Technical Service Bulletin

No.JTB00077v2
11 July 2008

Subject/Concern:	'Moan' Noise from Rear Brakes When Reversing or Manoeuvring Slowly
-------------------------	--------------------------------------------------------------------

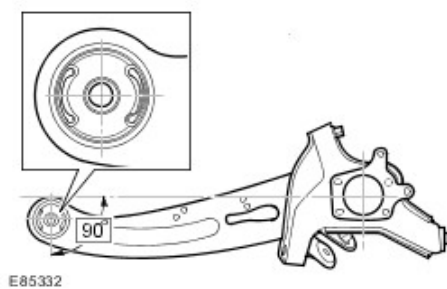
1. Remove rear knuckle front bushing (see Global Technical Reference GTR Workshop Manual, section: 204-02 - Rear Suspension - Wheel Knuckle Front Bushing (64.15.28)).
2. **NOTE:** The new bushing are voided, and the voids need to be in the correct orientation when installed (see E85332).

Install the new rear knuckle front bushing (see Global Technical Reference GTR Workshop Manual, section: 204-02 - Rear Suspension - Wheel Knuckle Front Bushing (64.15.28)).
